Recall Campaign Bulletin

Campaign No. 2020070017, August 2020

SUBJECT: Model C-Class, E-Class, and GLC-Class vehicles (205, 213, 253 platform)

Torque Value of Exhaust Turbocharger Screws

Figure 1

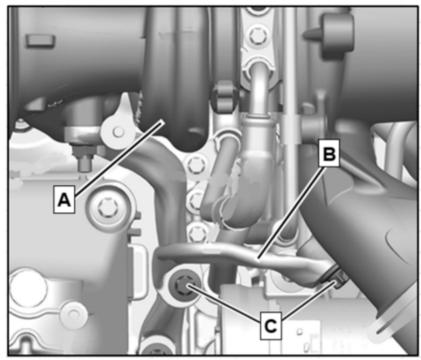
- i For basic data, see **AR20.10-P-1271MRH** (model 213).
- 4. Underneath the exhaust gas turbocharger (A, figure 1), unscrew the screws (C, figure 1) and remove the bracket (B, figure 1) (in model 205, 213, and 253 with M264).

Figure 2

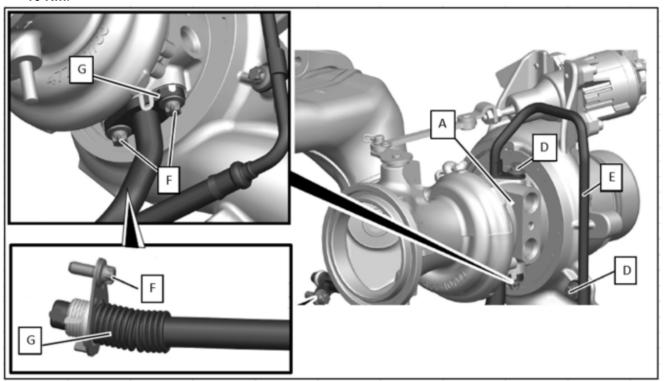
Mercedes-Benz AG, ("MBAG") the manufacturer of Mercedes-Benz vehicles, has determined that on certain Model Year ("MY") 2020 C-Class, E-Class, and GLC-Class vehicles (205, 213, 253 platform) equipped with a 4-cylinder gasoline engine (M264), the screws that retain the turbocharger oil feed and return lines may not have been properly torqued during the assembly process due to a deviation in the data documentation. As a result, the correct mounting of the assembly cannot be confirmed. Should the mounting assembly not meet the torque specification, the turbocharger oil feed and return lines could detach and leak oil, which could potentially contact hot engine components, increasing the risk of a fire. MBUSA will conduct a voluntary recall. An authorized Mercedes-Benz dealer will check the mounting of the turbocharger oil feed and oil return line on the affected vehicles and rework it, if necessary.

- 5. Remove front lower engine compartment lining.
 - i For basic data, see **AR61.20-P-1105LW** (model 205/253).
 - For basic data, see AR61.20-P-1105LWE (model 213).
- 6. Retighten screws (D, figure 2) of oil feed line (E, figure 2) at exhaust gas turbocharger (A, figure 2) with 10 Nm.
- 7. Retighten screws (F, figure 2) of oil return feed line (G, figure 2) at exhaust gas turbocharger (A, figure 2) with 10 Nm.
